The Hub at Tucson

Core Campus Developers | Antunovich Associates Architecture · Planning

Tucson, Arizona | May 15, 2014

Re: Additional West Elevation Windows Hub Tucson

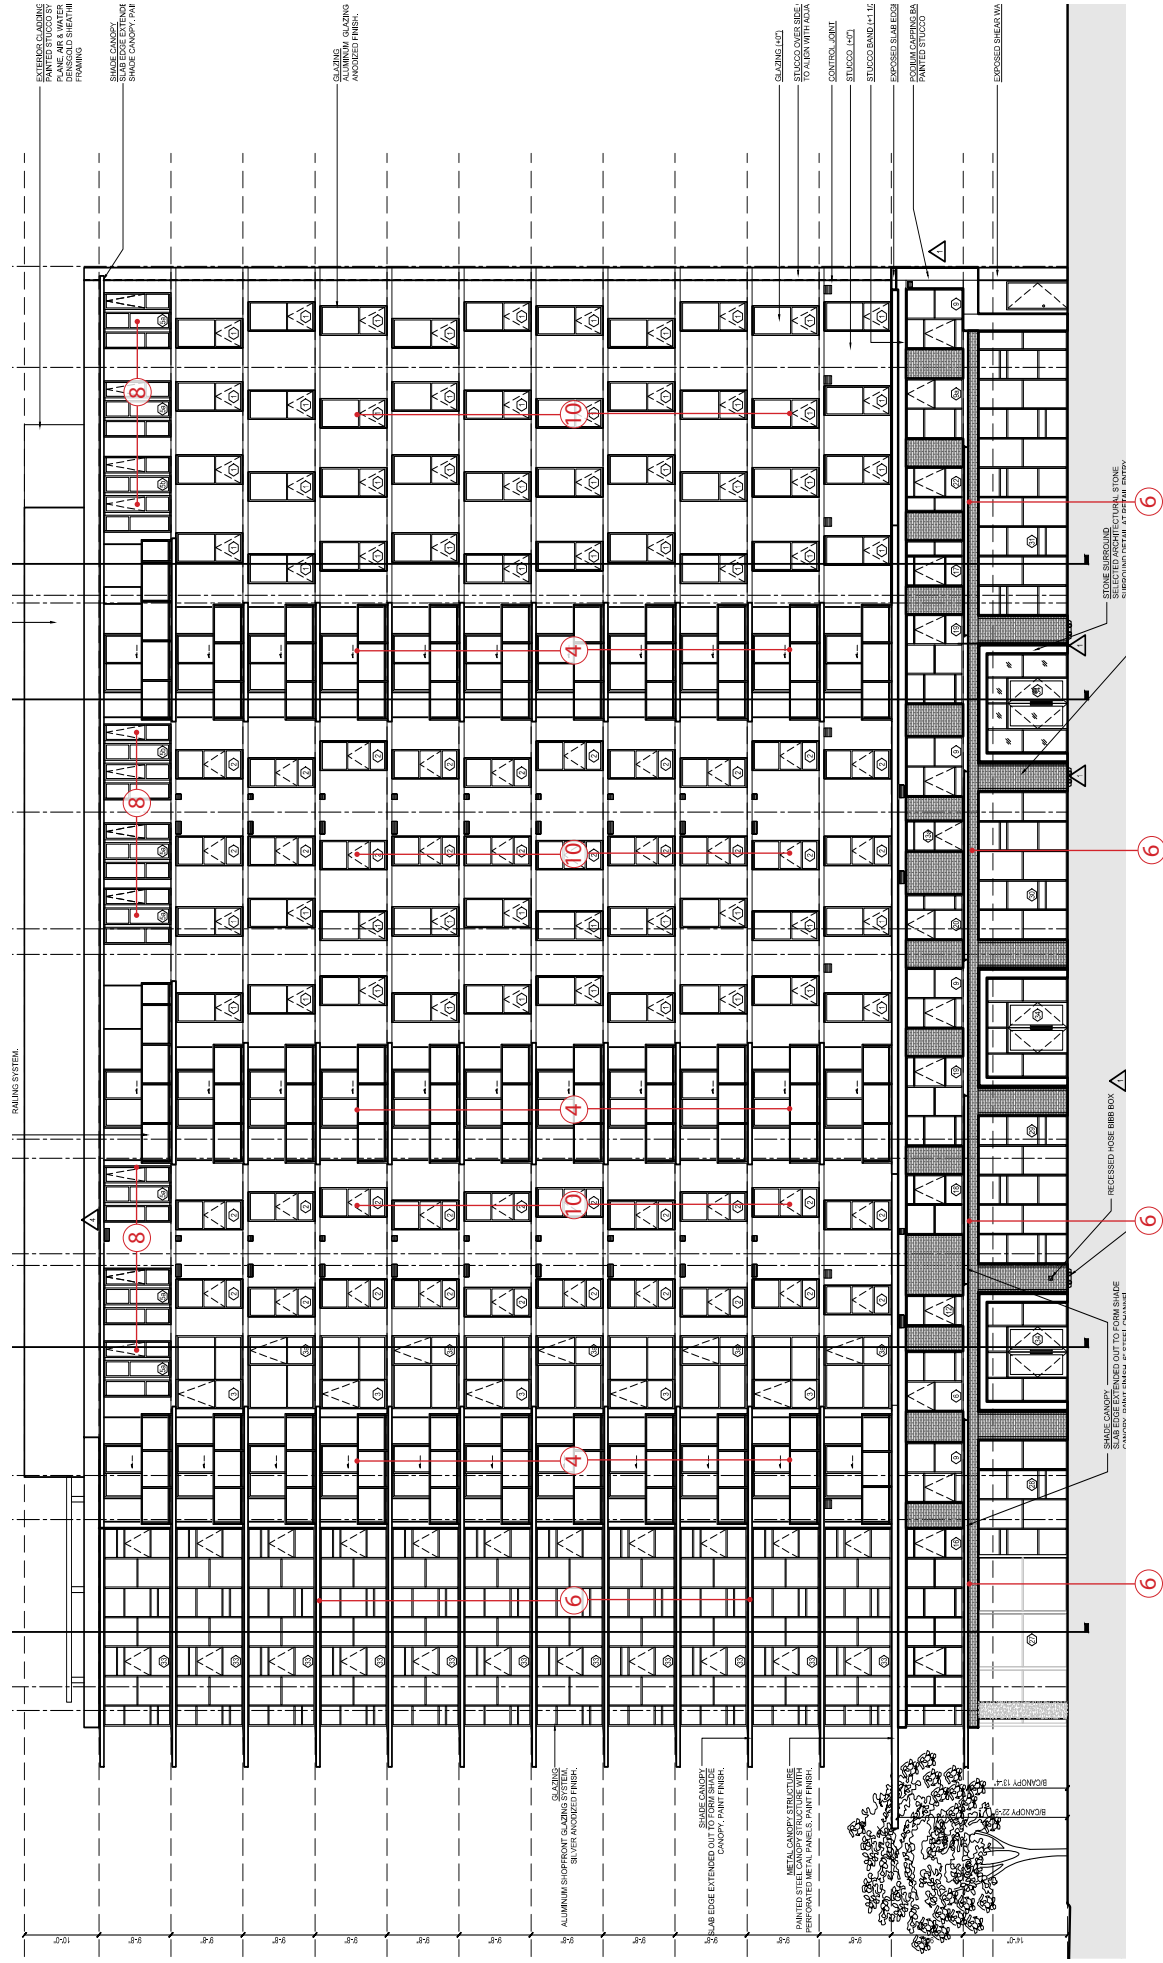
I wanted to send you a letter confirming our position on the addition of West Facing Windows for the above referenced project. It seems, even after numerous conversations, our point is not getting across, the walls as completed are a complete water tight assembly, once you cut into that assembly you have completely voided not only the warranty but the water tight integrity of the assembly, you are quite frankly asking for a future problem, whether it be in 6 months or 3 years problems will arise. We strongly recommend you do not cut into the elevation, in fact we are not willing to do so, and as discussed you can accomplish the required "look" through other options.

Revisions to Exterior Elevations Legend

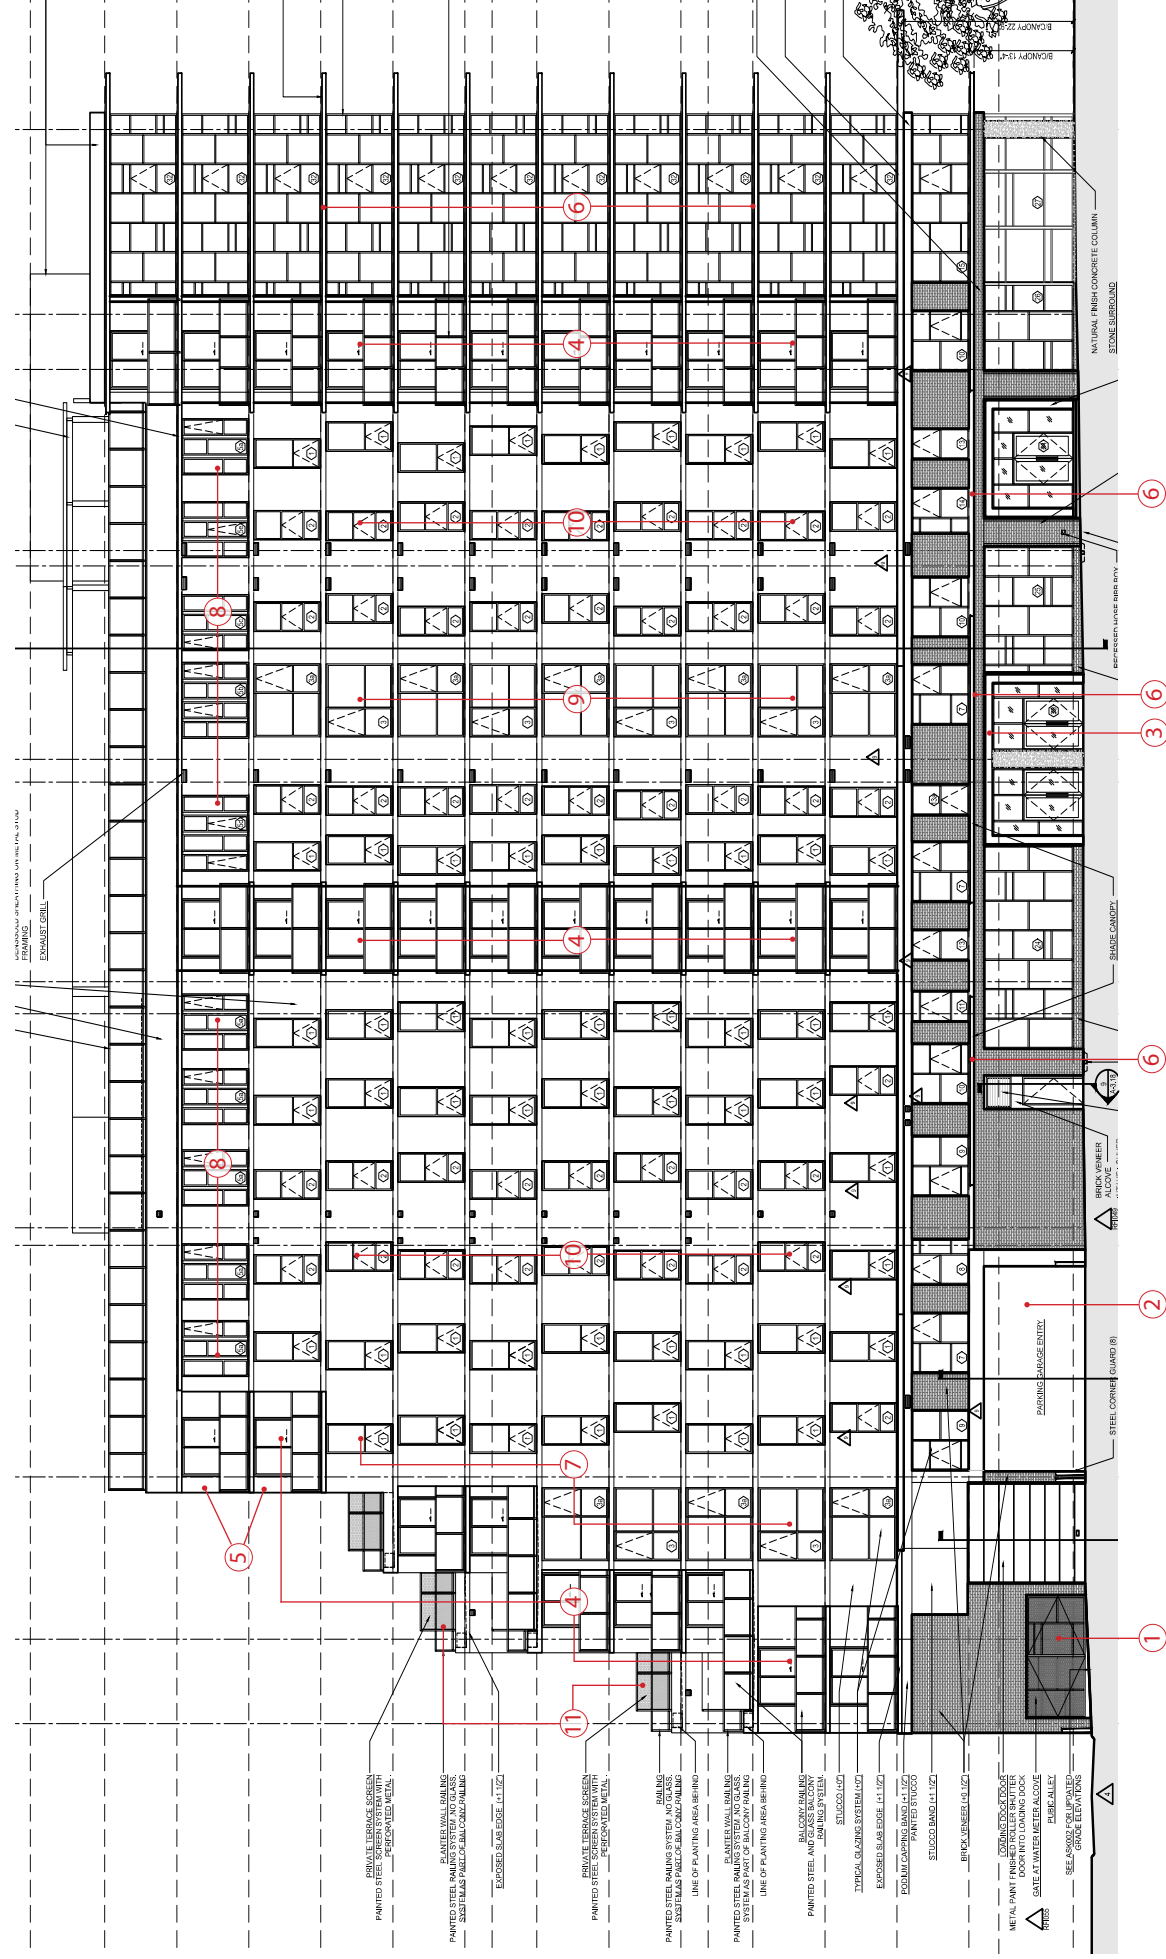
- Denotes revisions on given facade.
- 1. Grillage at face of building with mechanical equipment behind.
- 2. One large garage opening instead of two smaller openings.

- 3. First floor residential entry framed in stone instead of brick.
- 4. 2 panel full height glass sliding doors in lieu of 3 panel system
- 5. Addition of structural columns at west end of building

- 6. Finished concrete edge detail in lieu of steel
- 7. Revised pattern, less glazing at west end of building
- 8. Revised glazing pattern at 12th floor

- 9. Addition of larger glazing opening
- 10. Revised glazing / opening pattern
- 11. 72" custom perforated aluminum privacy screens around terraces in lieu of code required railing at roof edges

- 12. Addition of stair exit enclosure
- 13. Addition of mechanical grills which match surrounding background.
- 14. Exposed architectural concrete finish in Lieu of painted finish.

Revisions to Exterior Elevations Legend

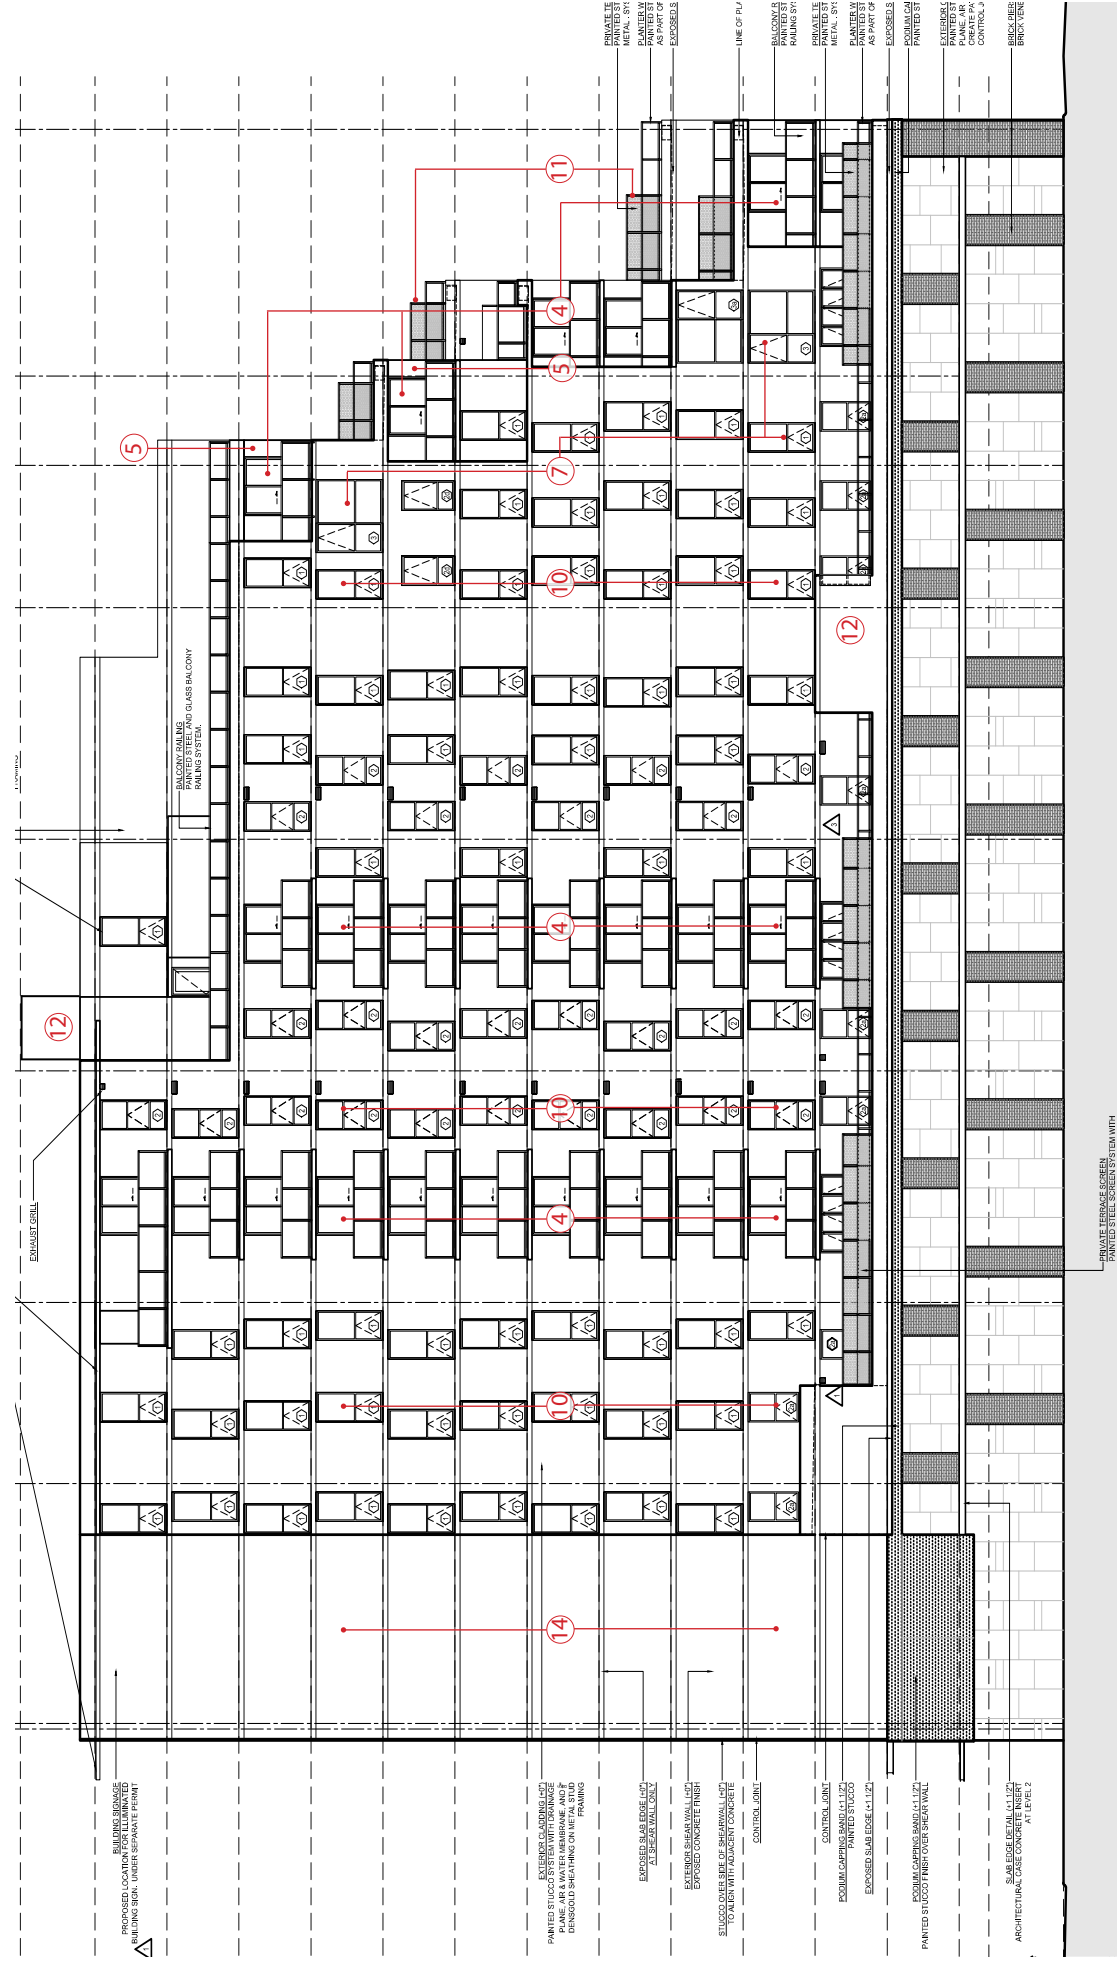
Denotes revisions on Given facade.

1. Grillage at face of building with mechanical equipment behind.
2. One large garage opening instead of two smaller openings.
3. First floor residential entry framed in stone instead of brick.
4. 2 panel full height glass sliding doors in lieu of 3 panel system
5. Addition of structural columns at west end of building

6. Finished concrete edge detail in lieu of steel
7. Revised pattern, less glazing at west end of building
8. Revised glazing pattern at 12th floor
9. Addition of larger glazing opening
10. Revised glazing / opening pattern
11. 72" custom perforated aluminum privacy screens around terraces in lieu of code required railing at roof edges

12. Addition of stair exit enclosure
13. Addition of mechanical grills which match surrounding background.
14. Exposed architectural concrete finish in Lieu of painted finish.
